New York Telephone Co.
G. W. McRAE, *Chief Engineer.*
J. J. ROBINSON, *Genl. Plant Manager.*

B599.081
~~Engineering Bulletin 444~~
May, 1925

PRIVATE BRANCH EXCHANGES—

#63 Induction Coil Telephone Set

FIGURE 1

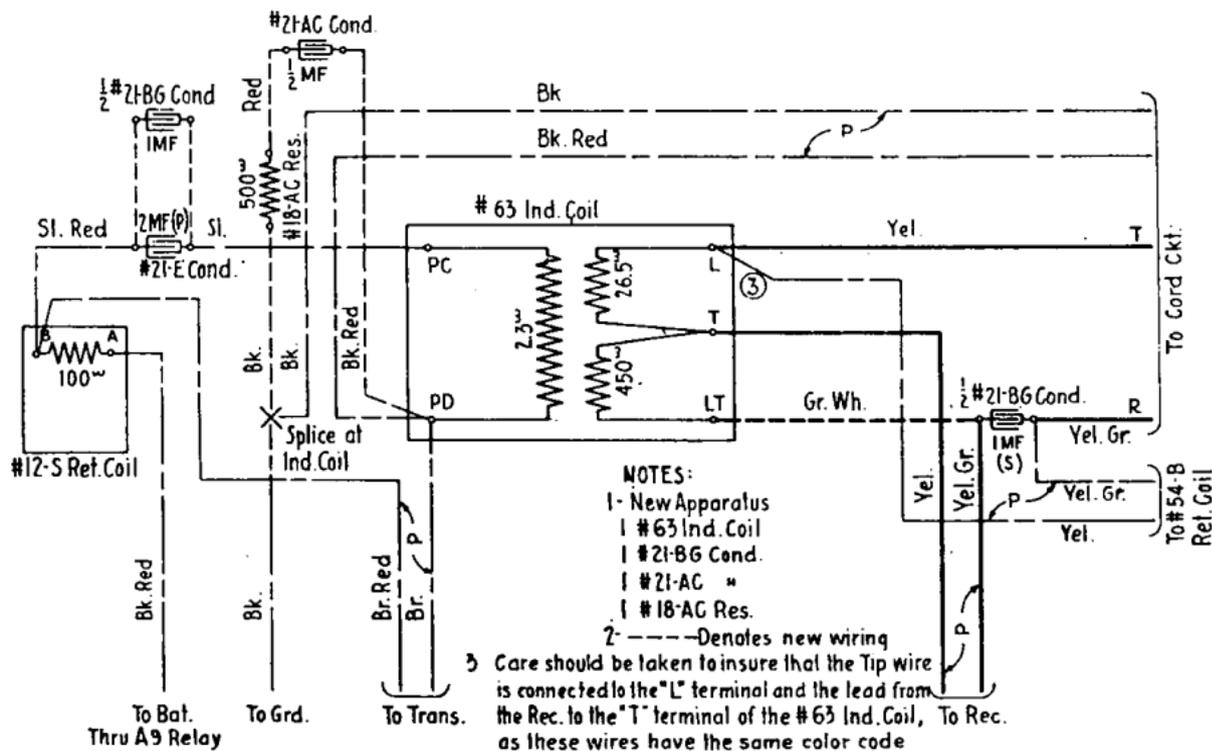
* 550-A P. B. X. SWITCHBOARD

Method of Rewiring Attendant's Telephone Set Circuit Using * 63 Induction Coil

FIGURE 2

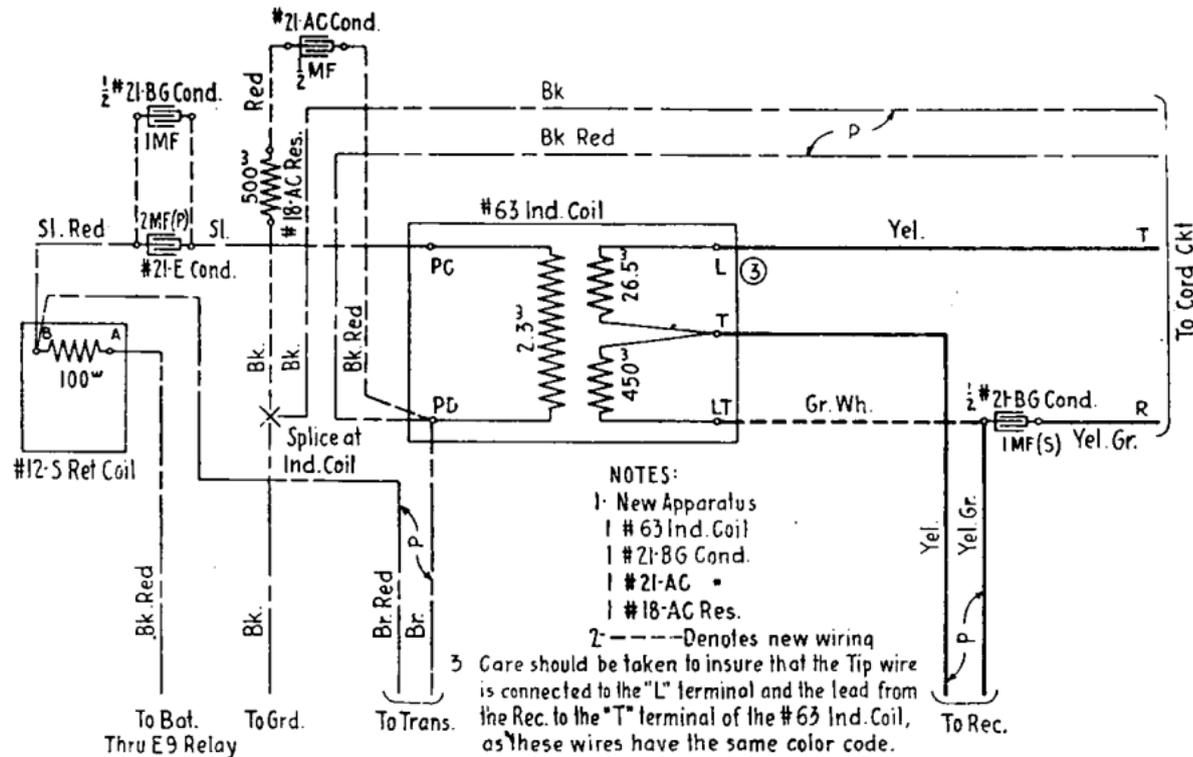
※ 550-B P. B. X. SWITCHBOARD

Method of Rewiring Attendant's Telephone Set Circuit Using ※ 63 Induction Coil

FIGURE 3

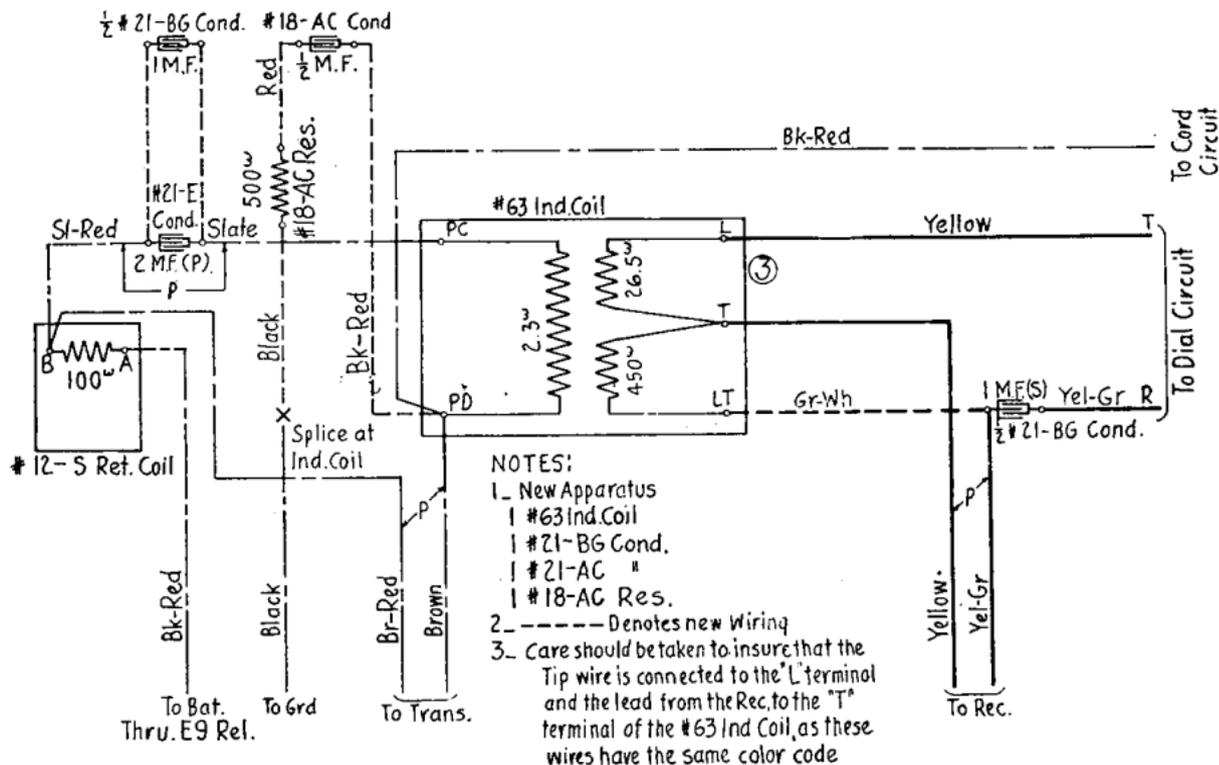
- NOTES:
1. New Apparatus
 1 # 63 Ind. Coil
 1 # 21-BG Cond.
 1 # 21-AC "
 1 # 18-AC Res.
 2. --- Denotes new Wiring
 3. Care should be taken to insure that the Tip wire is connected to the "L" terminal and the lead from the Rec. to the "T" terminal of the # 63 Ind. Coil, as these wires have the same color code

*** 550-C P. B. X. SWITCHBOARD WIRED PER CIRCUIT PASTER P-162190**
Method of Rewiring Attendant's Telephone Set Circuit Using # 63 Induction Coil

FIGURE 4

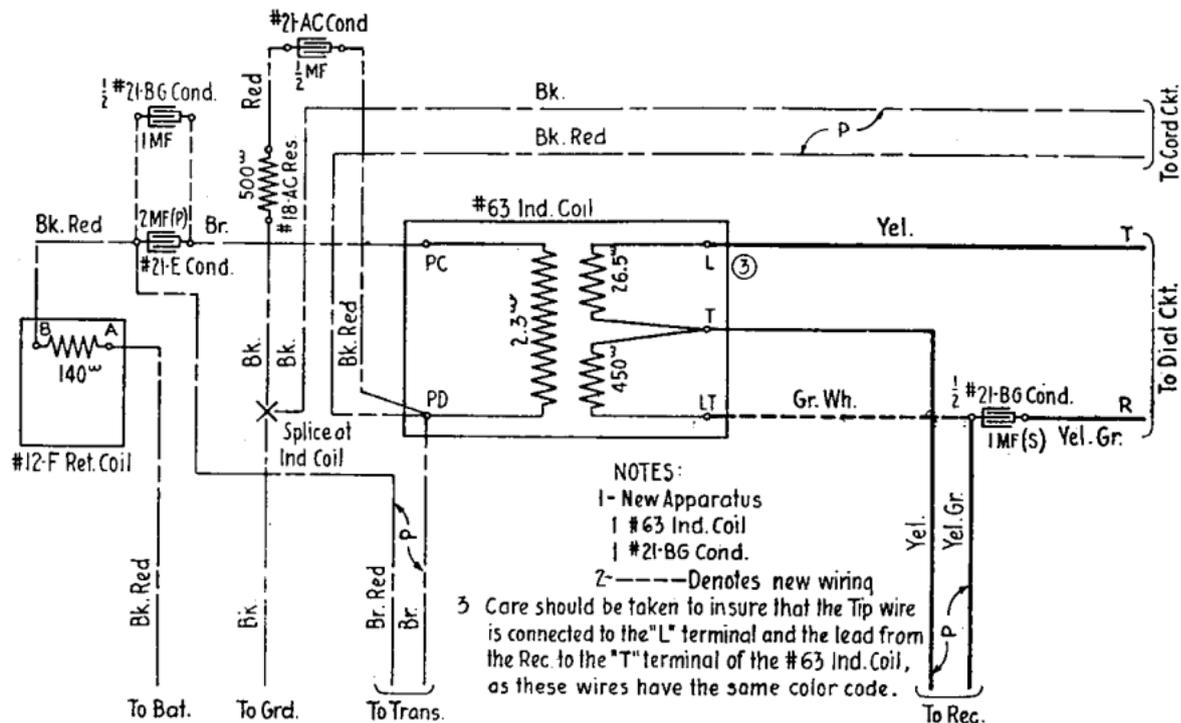
※ 550-C P. B. X. SWITCHBOARD WIRED PER CIRCUIT PASTER P-69227
 Method of Rewiring Attendant's Telephone Set Circuit Using ※ 63 Induction Coil

FIGURE 5

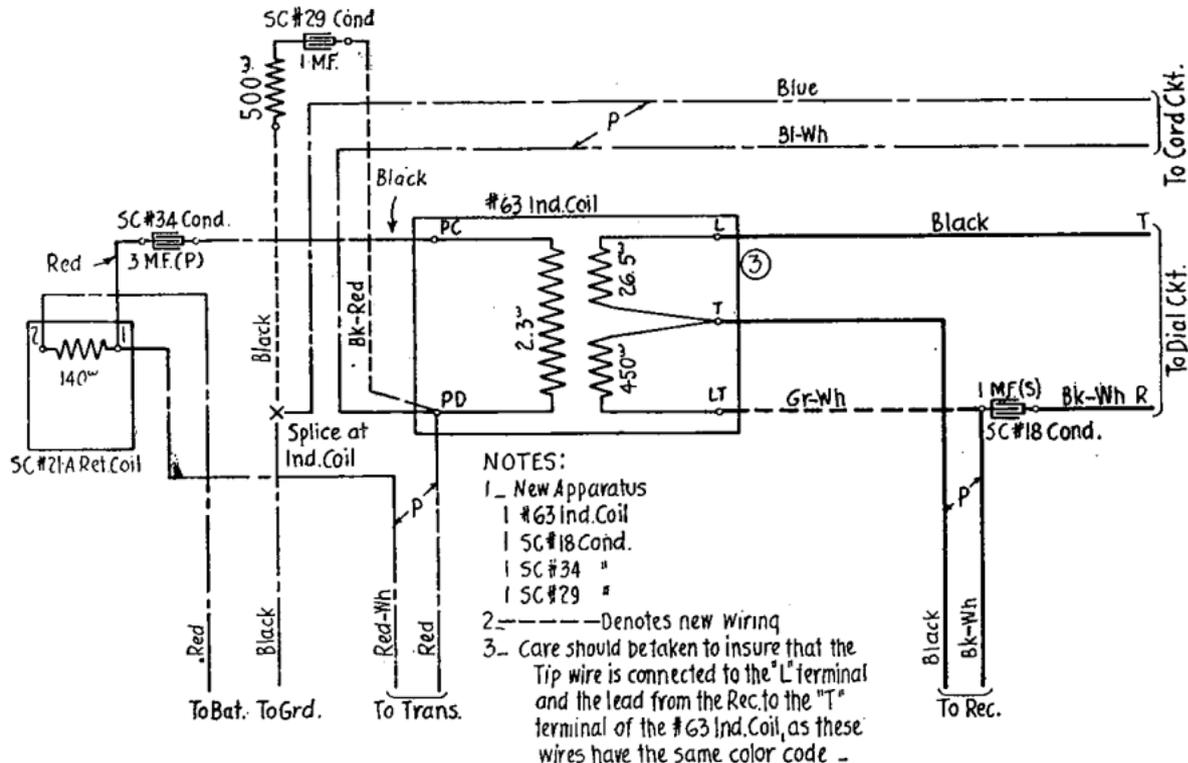
※ 550-SC P. B. X. SWITCHBOARD WIRED PER CIRCUIT PASTER FORM ※ 948
Method of Rewiring Attendant's Telephone Set Circuit Using ※ 63 Induction Coil

FIGURE 6

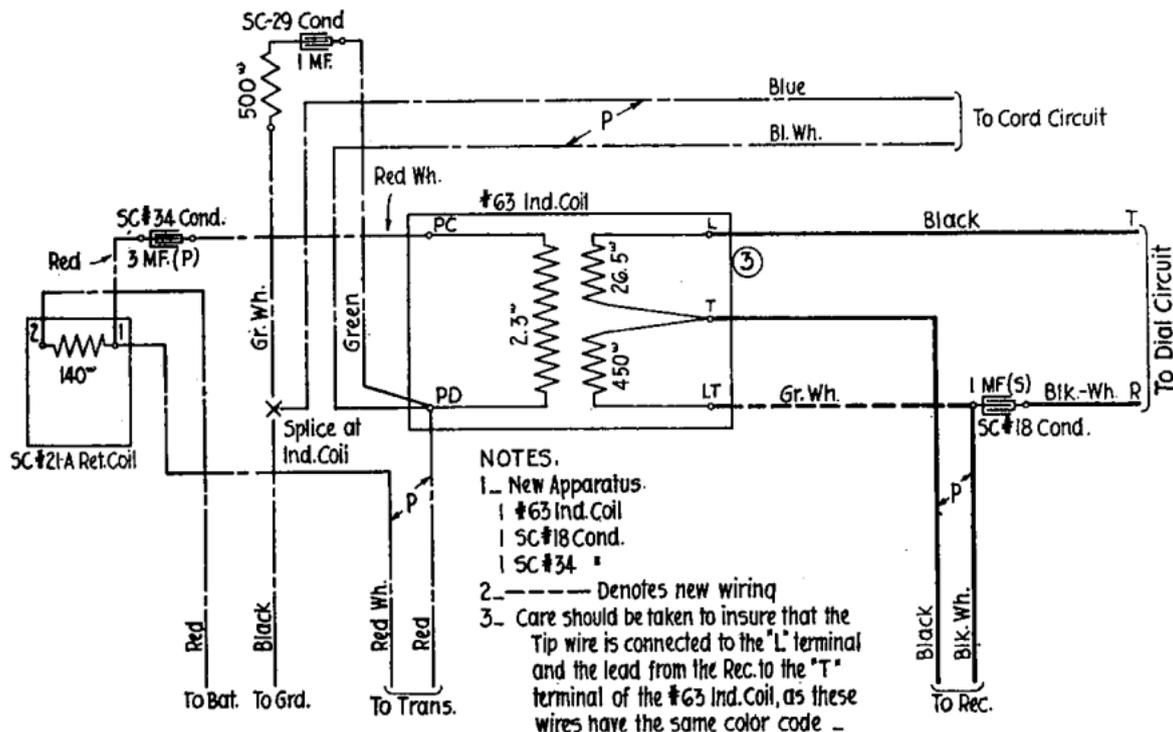
※ 550-SC P. B. X. SWITCHBOARD WIRED PER CIRCUIT PASTER FORMS ※ 967 and ※ 1078
Method of Rewiring Attendant's Telephone Set Circuit Using ※ 63 Induction Coil

FIGURE 7

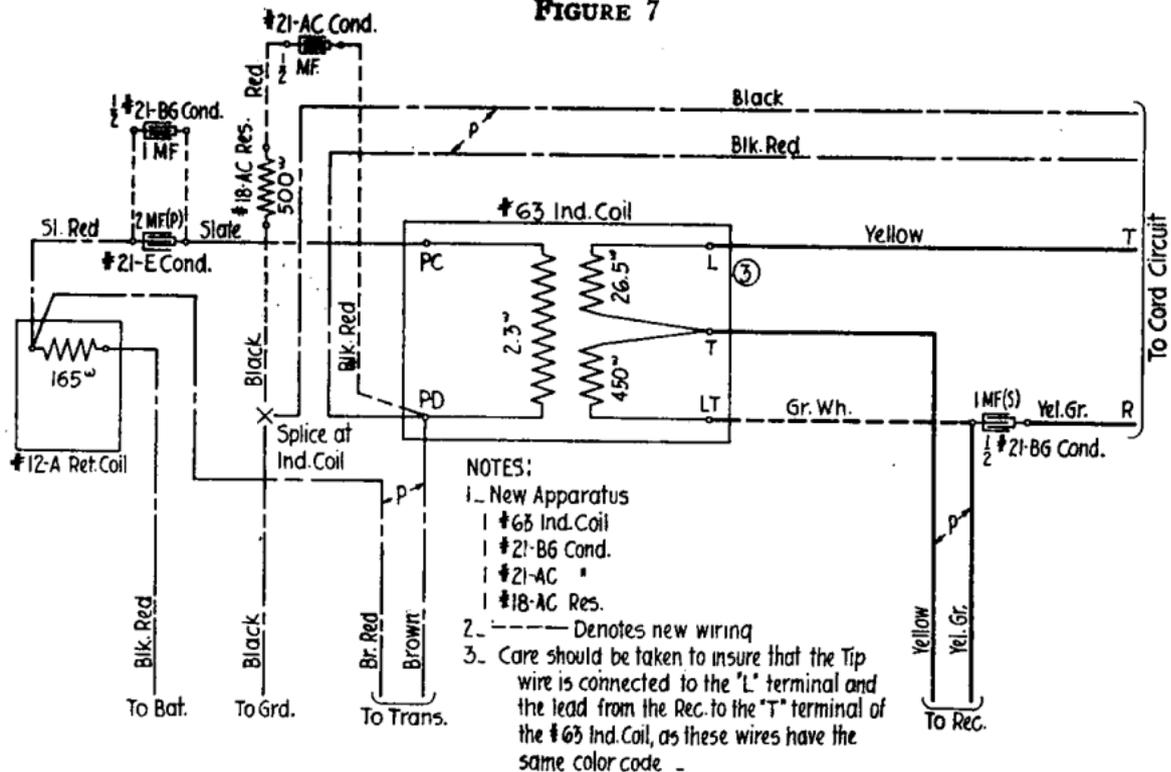
1. New Apparatus
 - 1 #63 Ind. Coil
 - 1 #21-BG Cond.
 - 1 #21-AC Cond.
 - 1 #18-AC Res.
2. --- Denotes new wiring
3. Care should be taken to insure that the Tip wire is connected to the "L" terminal and the lead from the Rec. to the "T" terminal of the #63 Ind. Coil, as these wires have the same color code.

※ 600-A and 600-B P. B. X. SWITCHBOARD

Method of Rewiring Attendant's Telephone Set Circuit Using ※ 63 Induction Coil

FIGURE 8

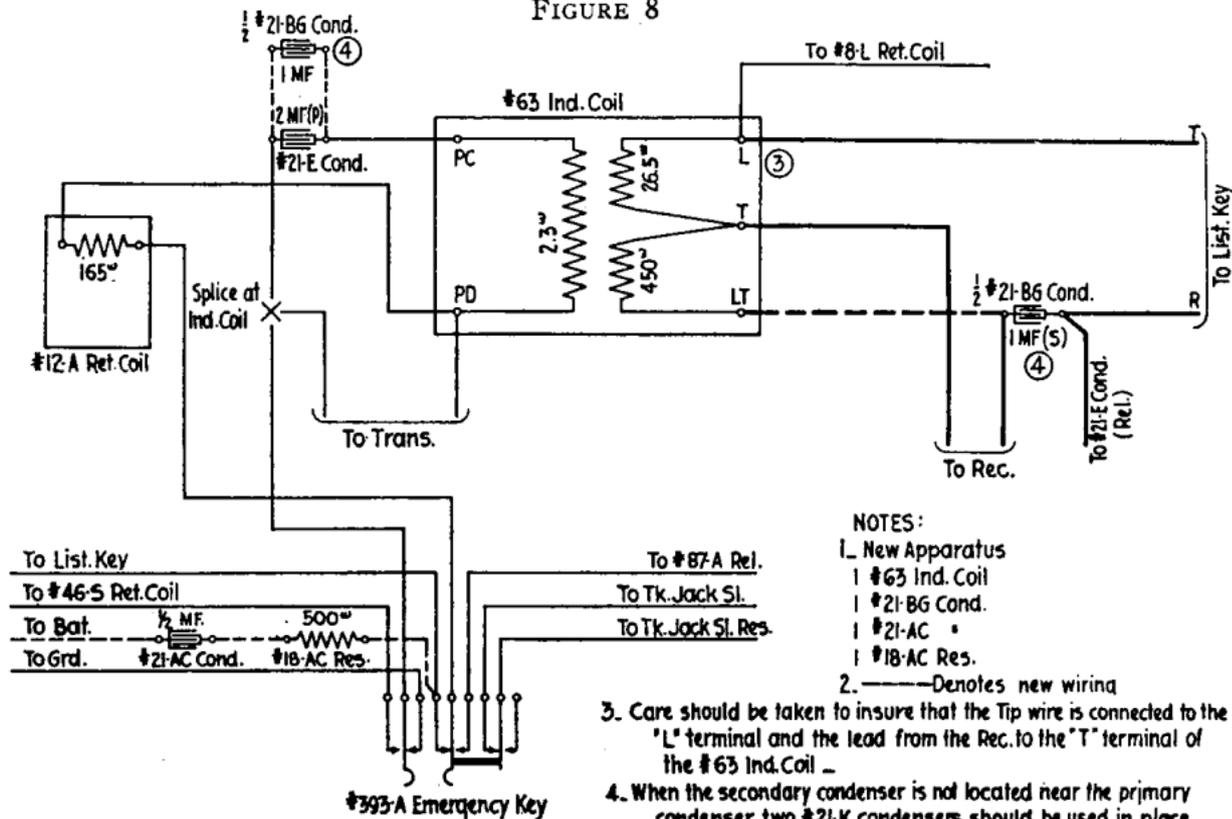
1. New Apparatus
 - 1 #63 Ind. Coil
 - 1 1/2 #21-BG Cond.
 - 1 #21-AC
 - 1 #18-AC Res.

2. ——— Denotes new wiring

3. Care should be taken to insure that the Tip wire is connected to the "L" terminal and the lead from the Rec. to the "T" terminal of the #63 Ind. Coil —
4. When the secondary condenser is not located near the primary condenser two #21-K condensers should be used in place of the #21-BG.

1 MAGNETIC SIGNAL P. B. X. SWITCHBOARD

Method of Rewiring Attendant's Telephone Set Circuit Using # 63 Induction Coil
